# Access Compliance Report Public Rights-of-Way (Curb Ramps)

Main Street: GARDENIA\_ST Cross Street: SNOW\_BUSH\_ST Location: SE

ADA ID: RPRK211028134045 Ramp Type: Type 4 - Parallel Initial Pass/Fail: Pass Overall Compliance: No Severity Score: 25

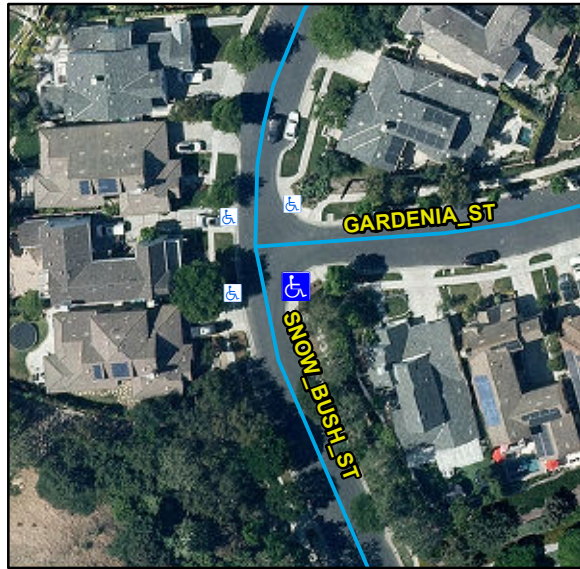
R304.2.2, R204.3, R304.2.1, R304.2.2-Perp, R304.3.2-Para, R304.5.3, R305, R302.7, R304.5.4, STD 1115

Remove & Replace Curb Ramp With Two New Directional Ramps or Equivalent. Remove & Replace Gutter.
